Report pursuant to s 42A Resource Management Act 1991

A Notice of Requirement to construct, operate, use, maintain and improve approximately 11.5km of new State Highway connection between Ashhurst and Woodville

Section 42A Technical Evidence: Noise

By: Nigel Lloyd

Figure 2. Arial 50 Acre block at rear of 75 Hope Road, Woodville (Ramage Property)

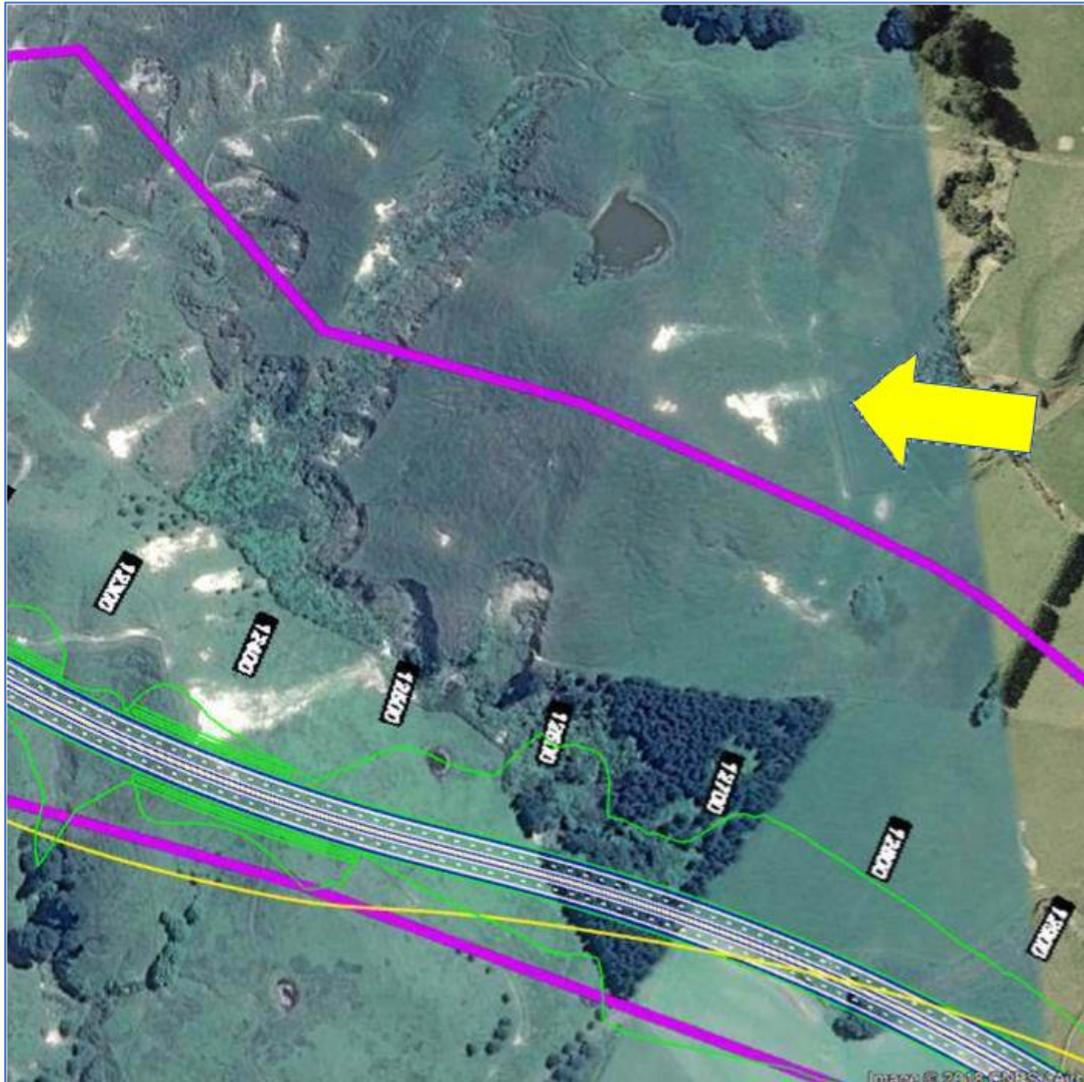
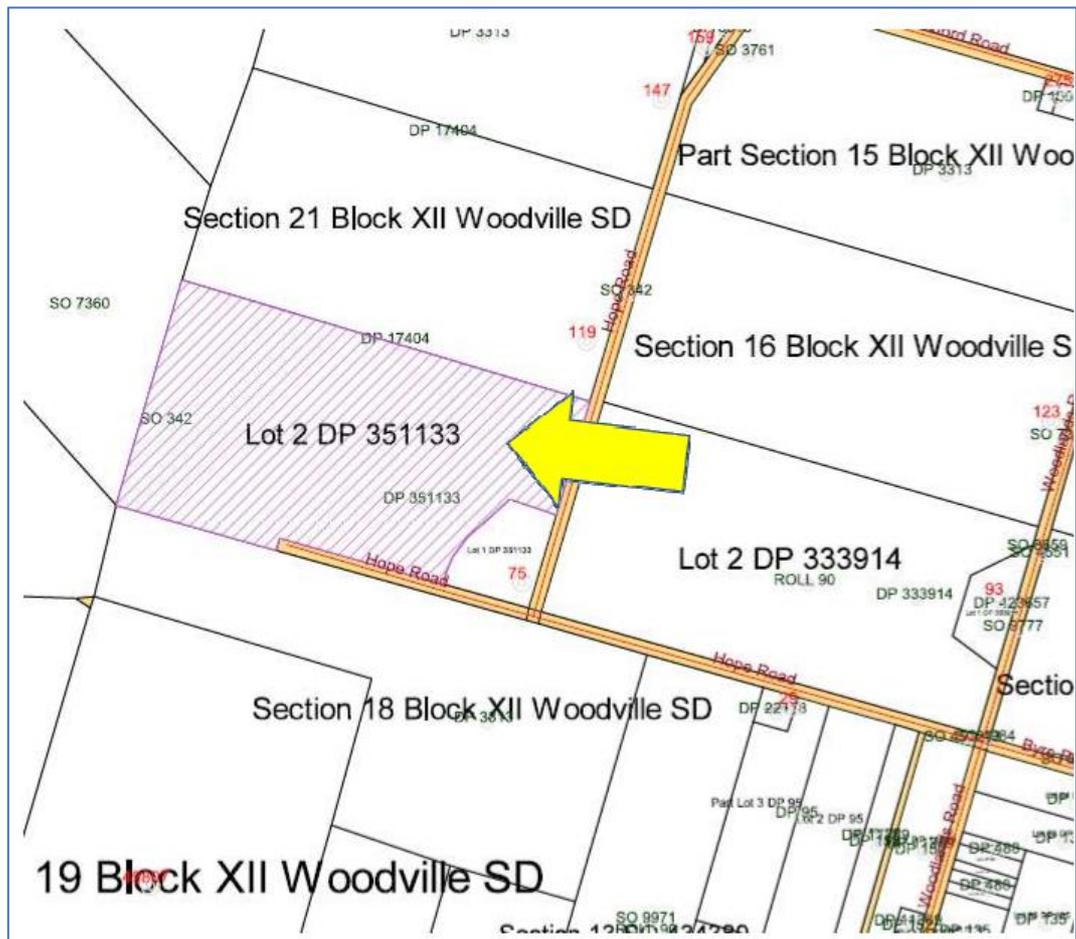
62. Murray Ramage owns a 50-acre block of land (Lot: 2 DP: 351133) (see *Figure 2* and *Figure 3*) which is at the rear of 75 Hope Road. The land has no dwellings and (I understand) no consent for any dwellings. The submitter has future plans to construct a dwelling as a lifestyle bock to retire on.

64. The submitter seeks that the property be included as a directly affected property in the NOR, and to require NZTA to enter discussions and negotiations regarding suitable mitigation actions in terms of traffic noise.

65. Drawing N-09 in Volume 4 of the AEE indicates that the noise contours are lower on the submitter's land, but this is because the road is elevated on fill. This would not prevent the noise propagating over the submitter's land.

66. There are no dwellings on this land that qualify as PPFs in terms of NZS 6806. The submitter is correct that the noise of the road will significantly alter the existing aural environment at his property. As a result, the submitter seeks to negotiate with NZTA, however any negotiations with NZTA would otherwise be a private matter.
